FINAL DRAINAGE PLAN

THE RIDGE AT LORSON RANCH

FILING NO. 1: SF 22-XX ← SF224

JANUARY, 2022

POND C2.1
FULL SPECTRUM
OUTLET STRUCTURE DETAILS

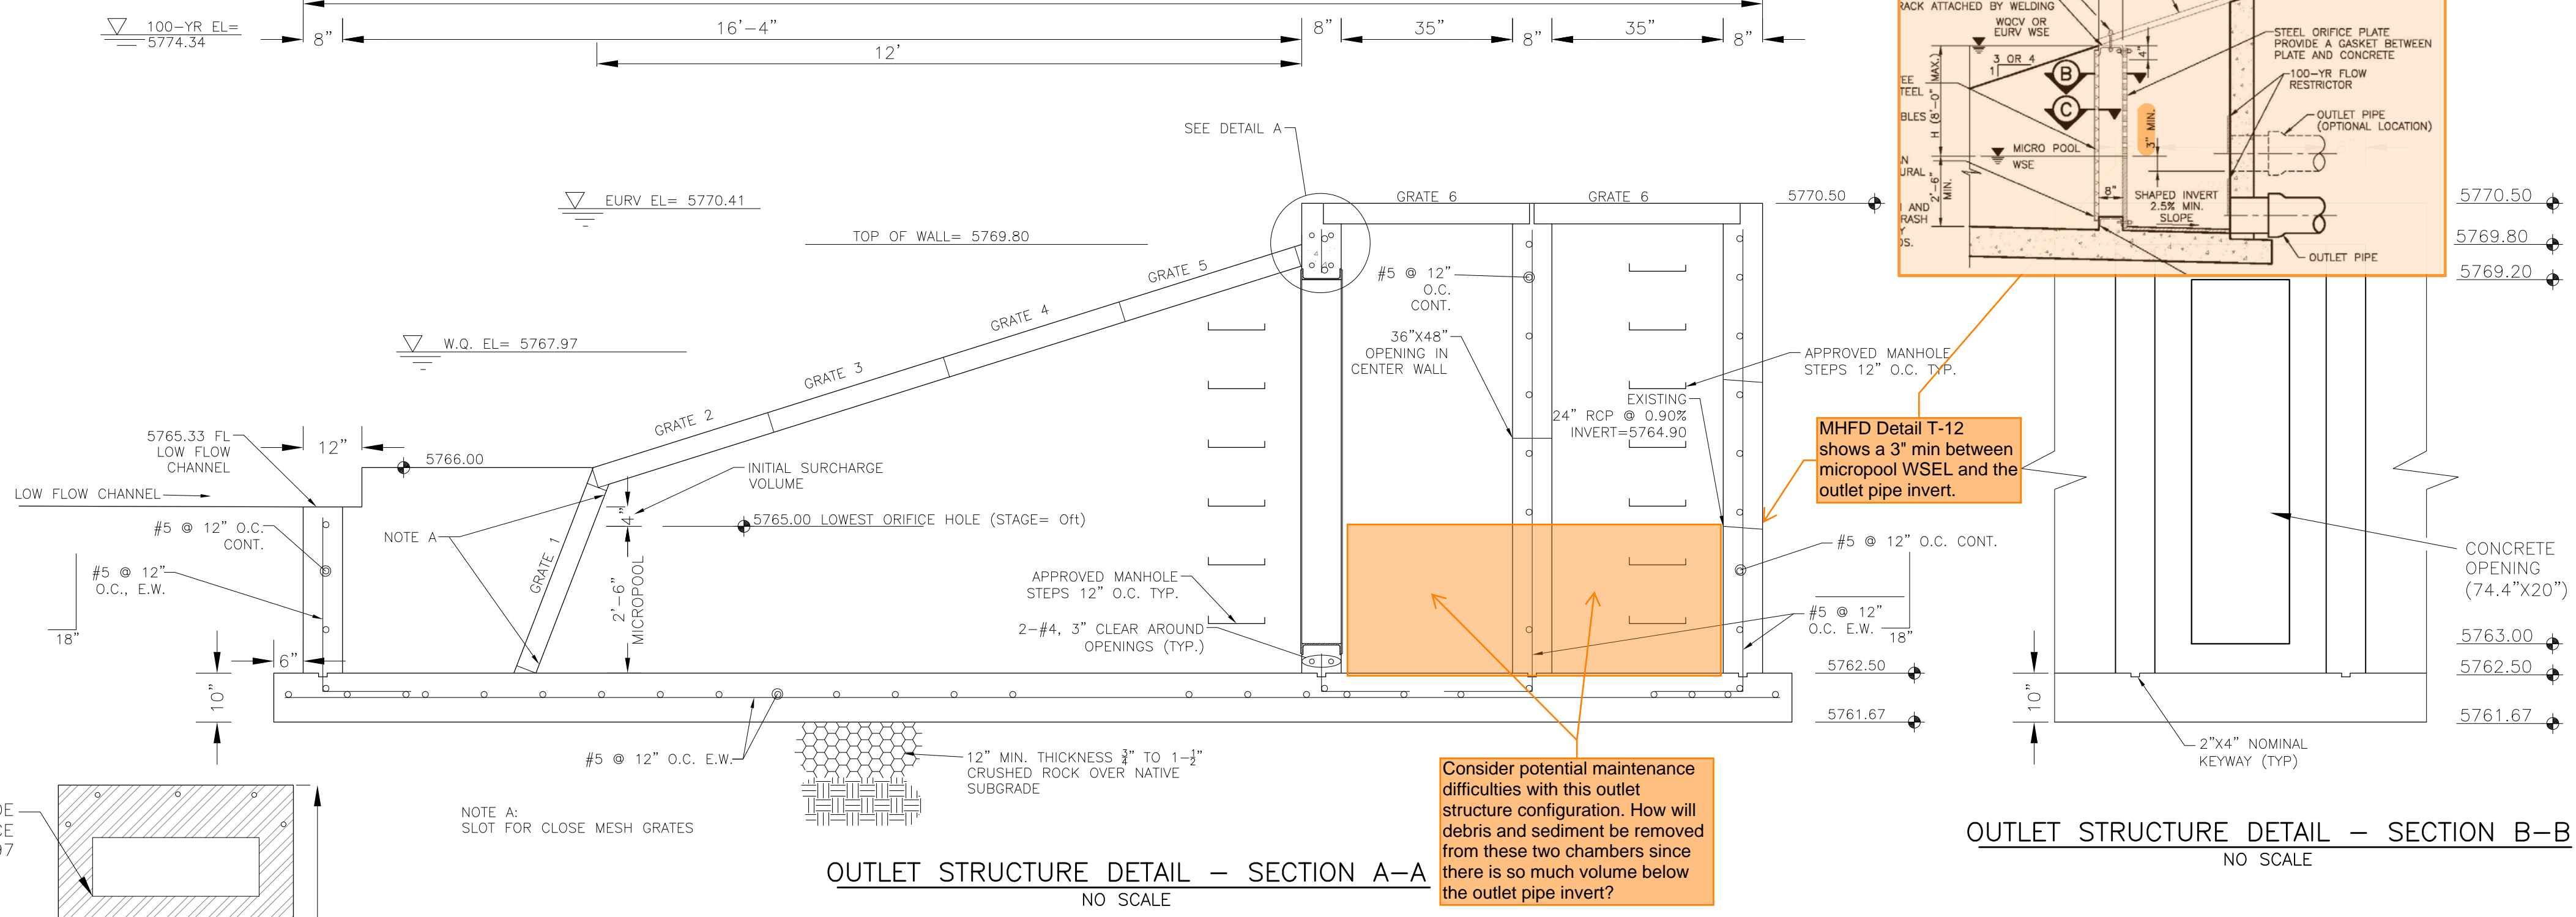
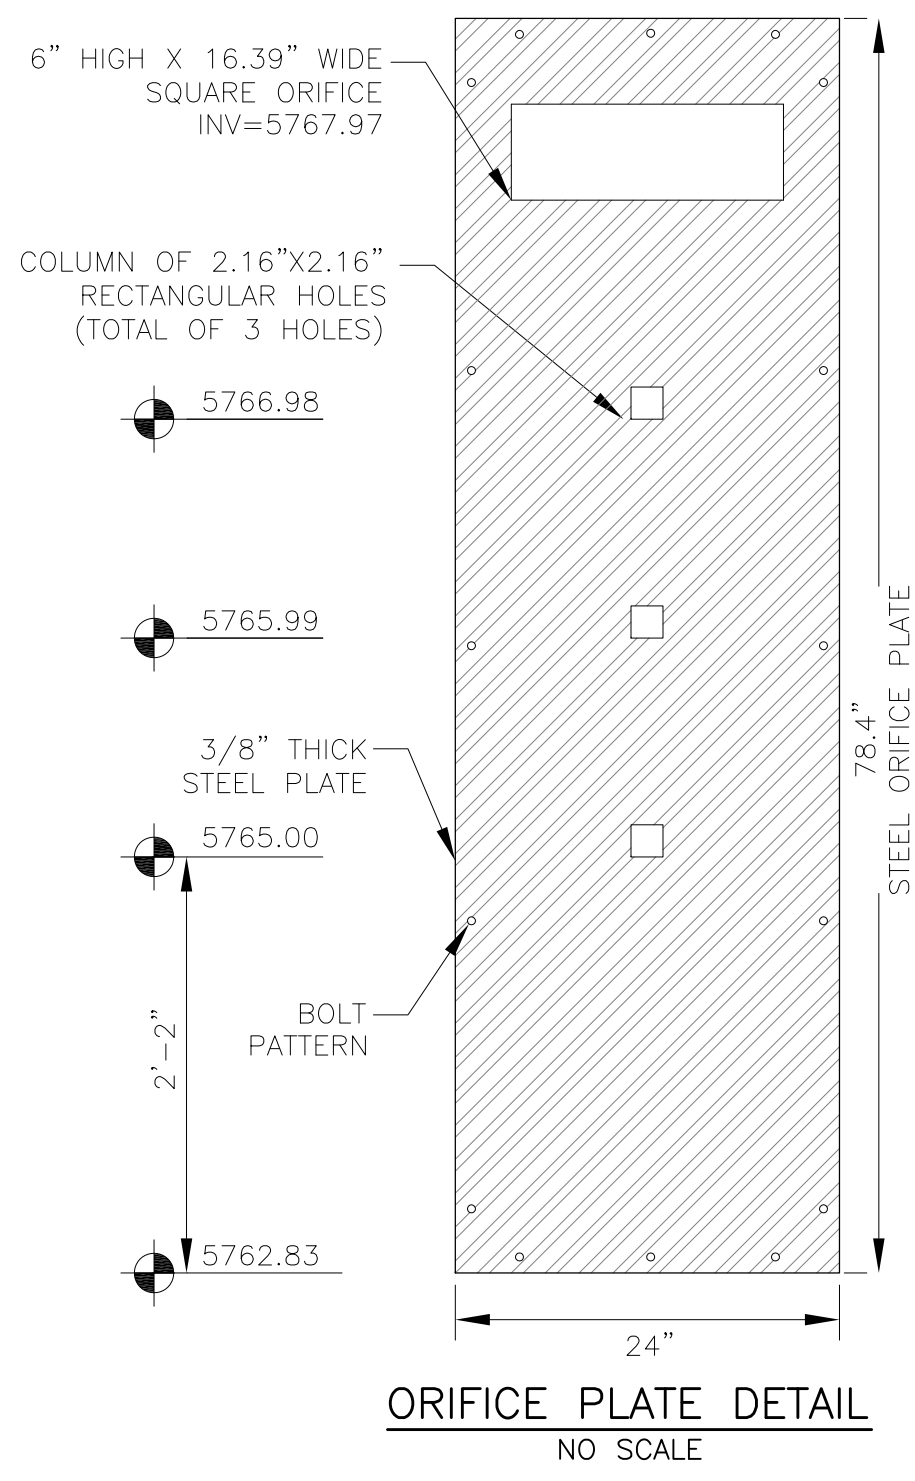
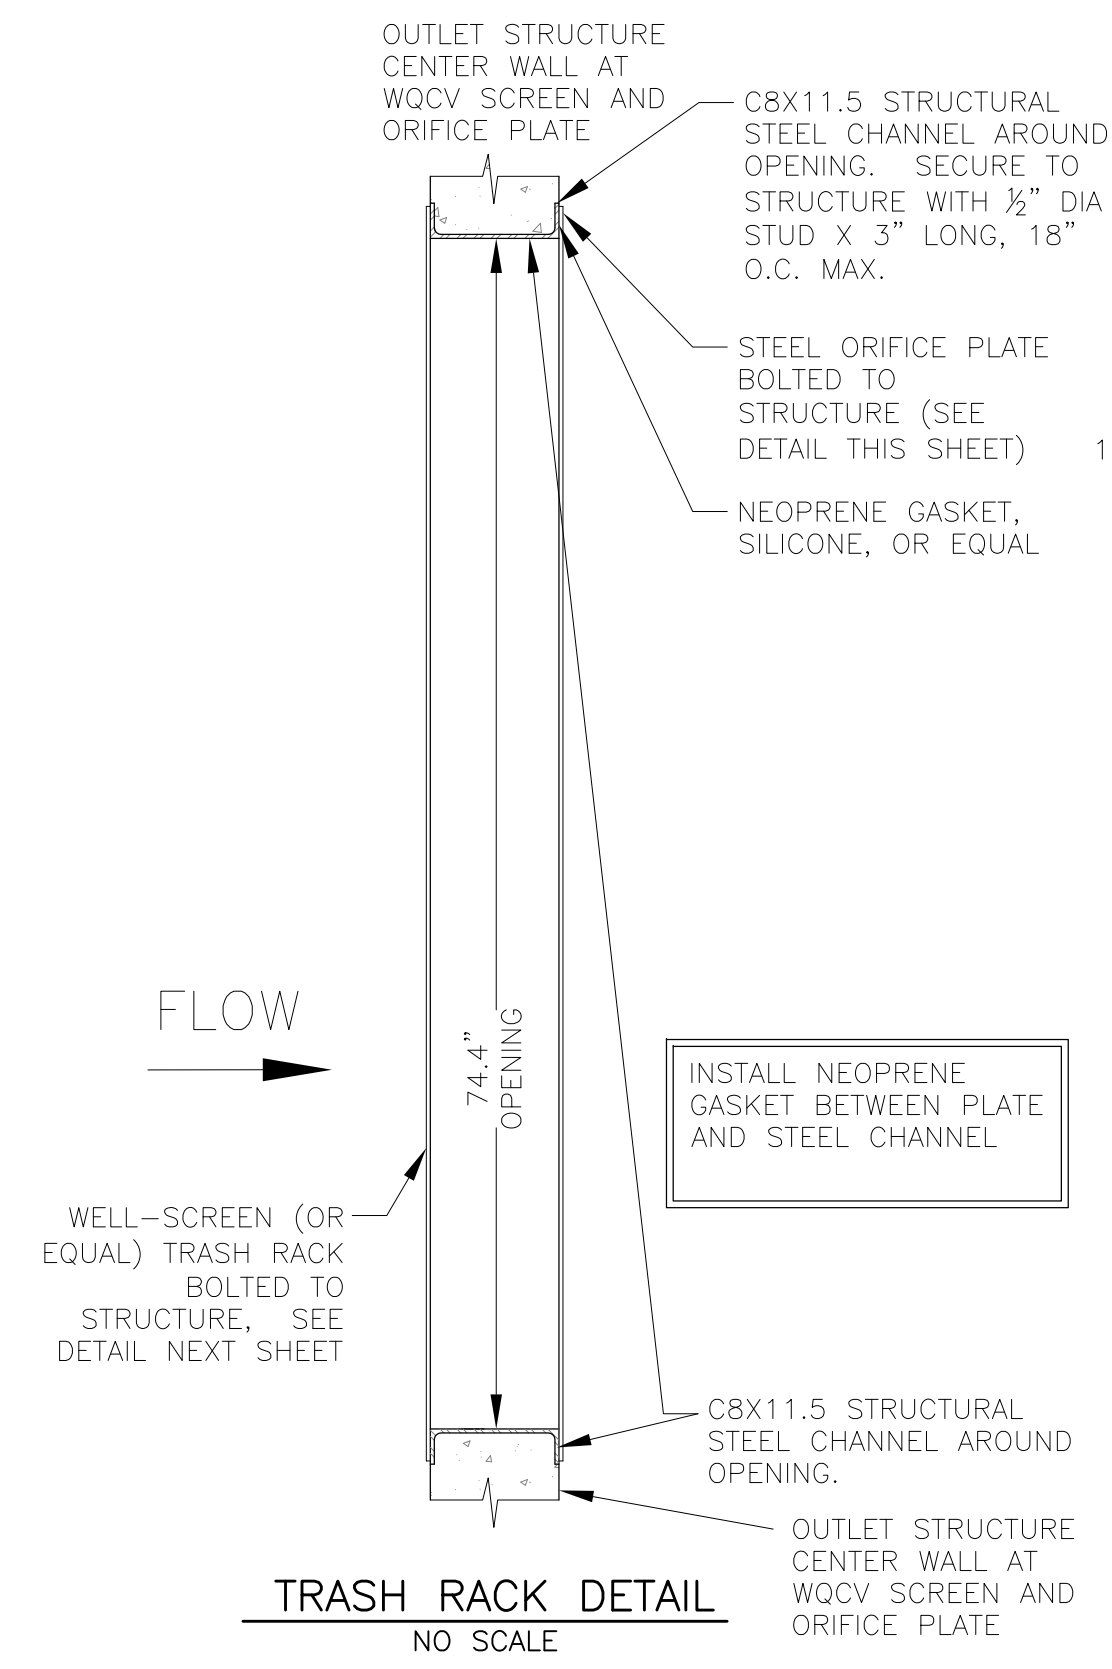
Pg 190 above shows that this should be 72"

MHFD Detail T-12 shows a 3" min between micropool WSEL and the outlet pipe invert.

Consider potential maintenance difficulties with this outlet structure configuration. How will debris and sediment be removed from these two chambers since there is so much volume below the outlet pipe invert?

**EXISTING CONDITIONS
PUD / PRELIMINARY PLAN
THE RIDGE AT LORSON RANCH**

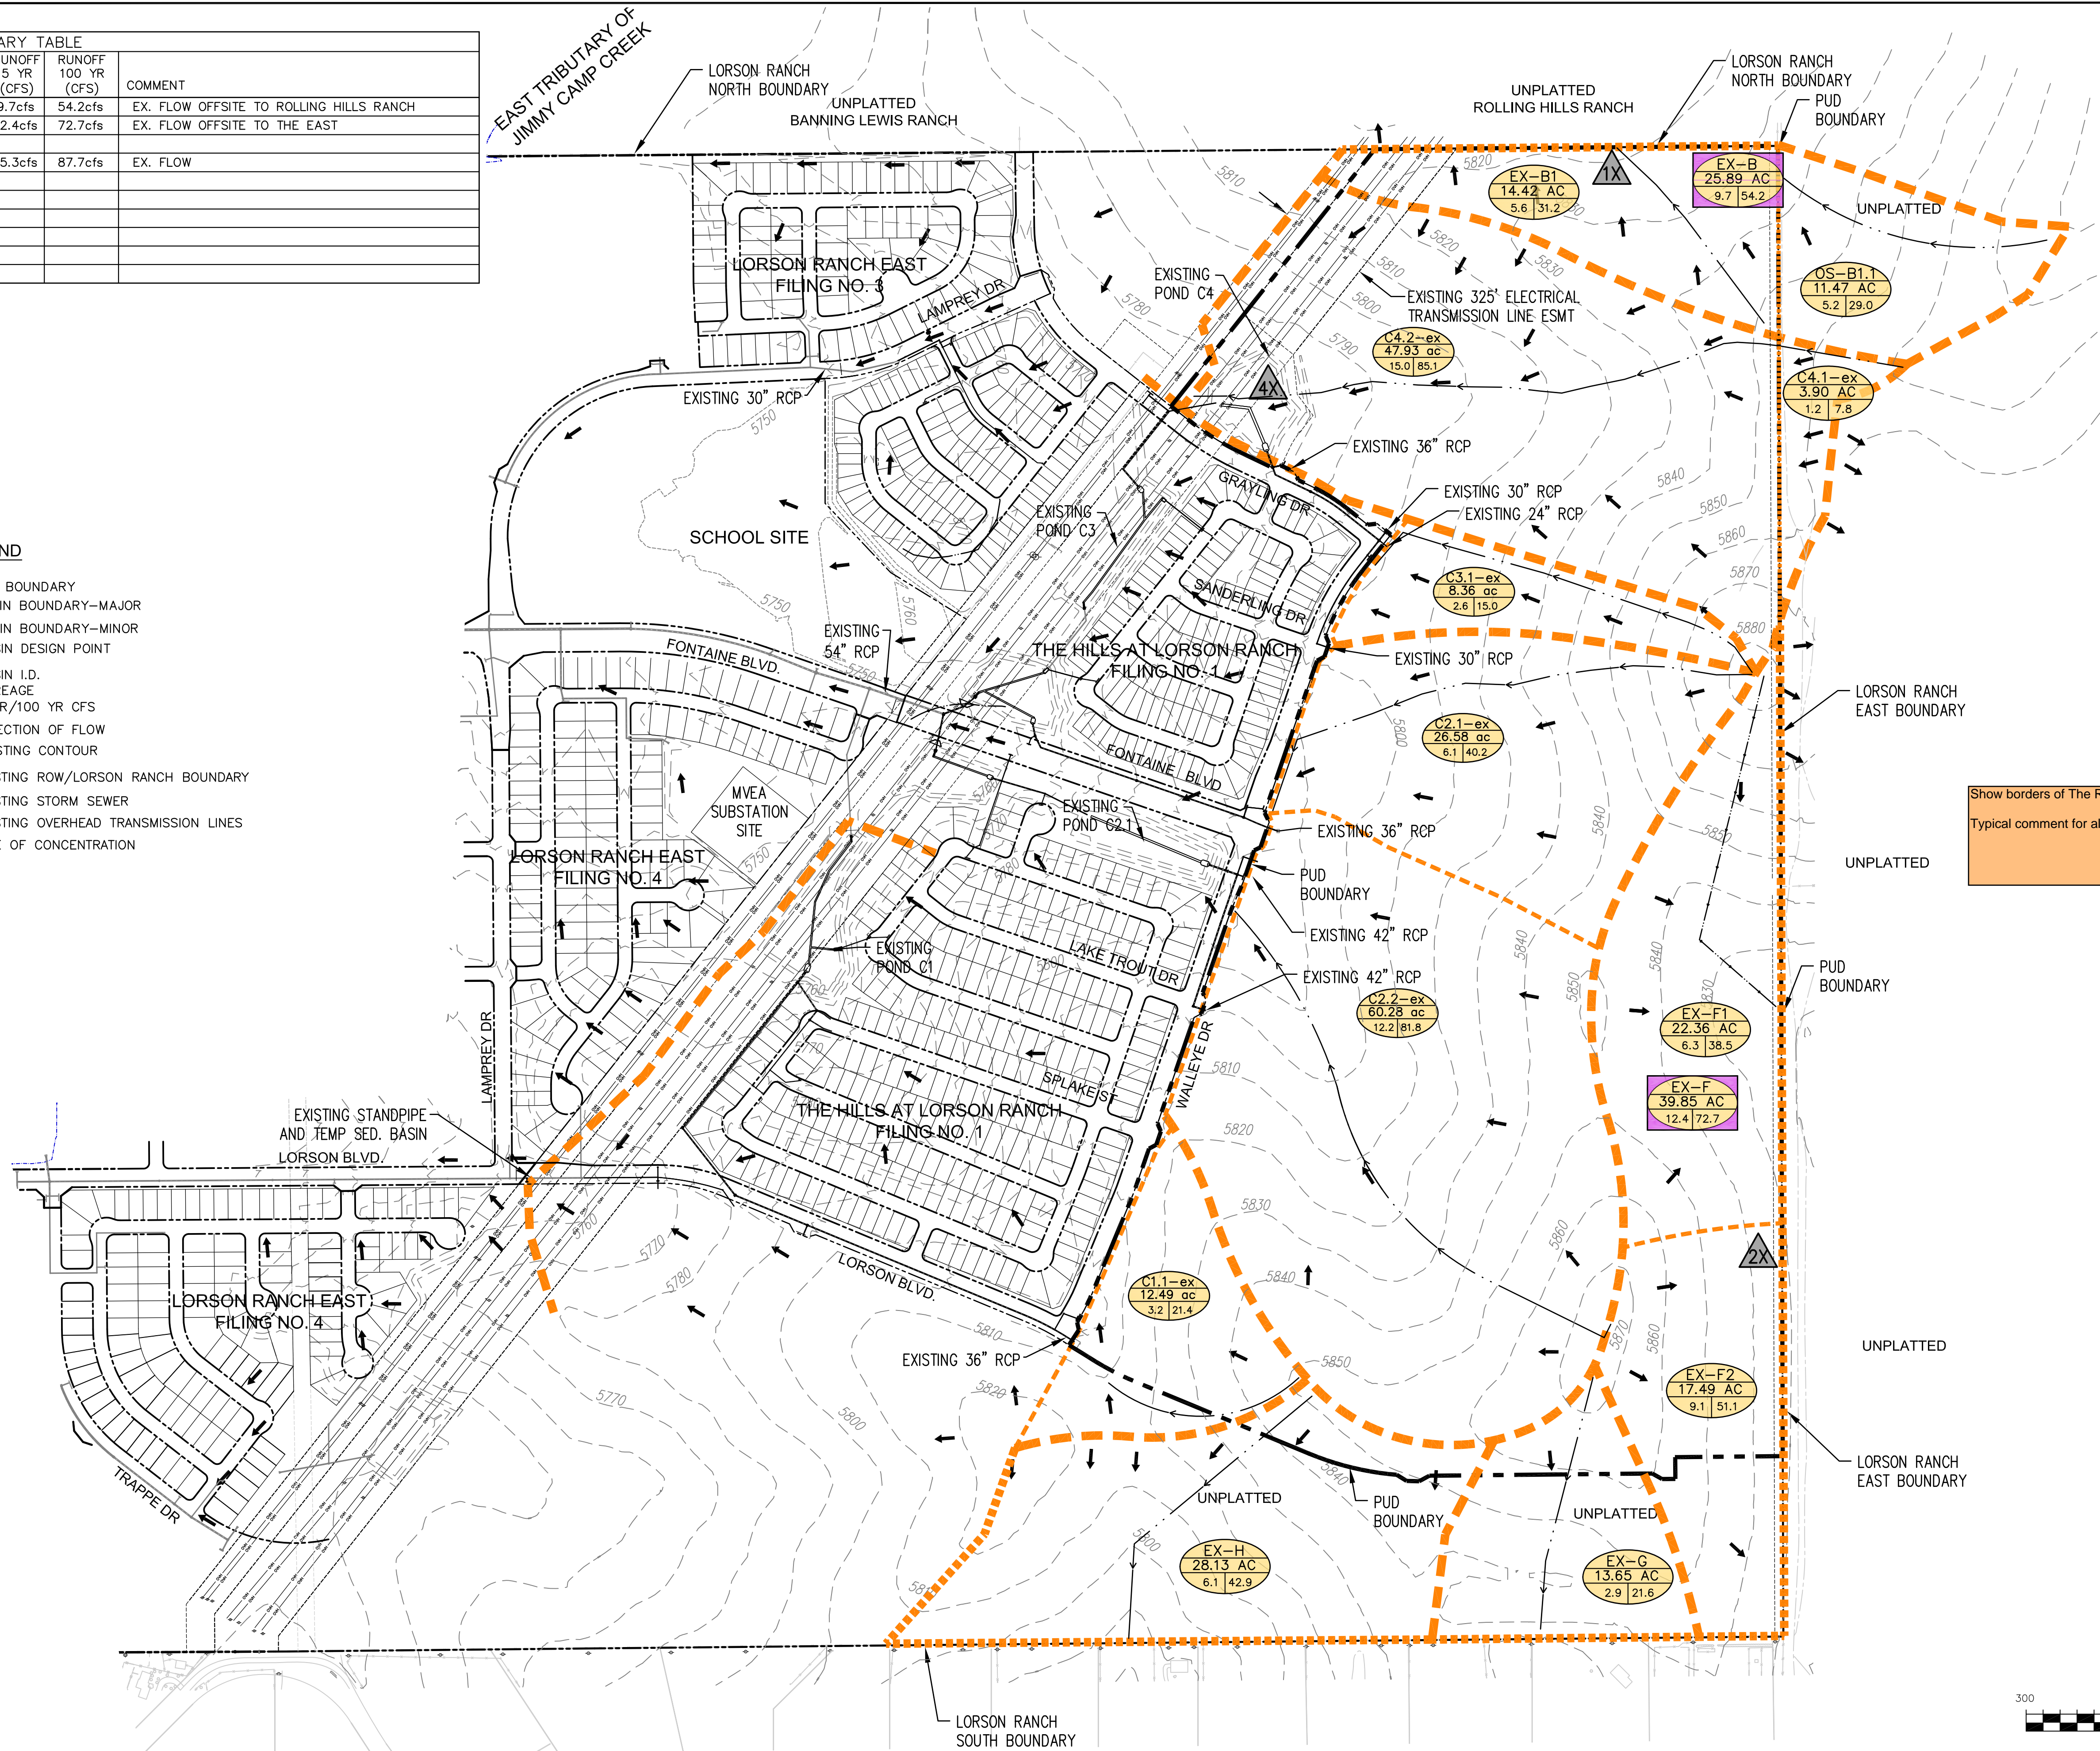
Show borders of The Ridge Filings 1, 2, and 3.
Typical comment for all subsequent maps.
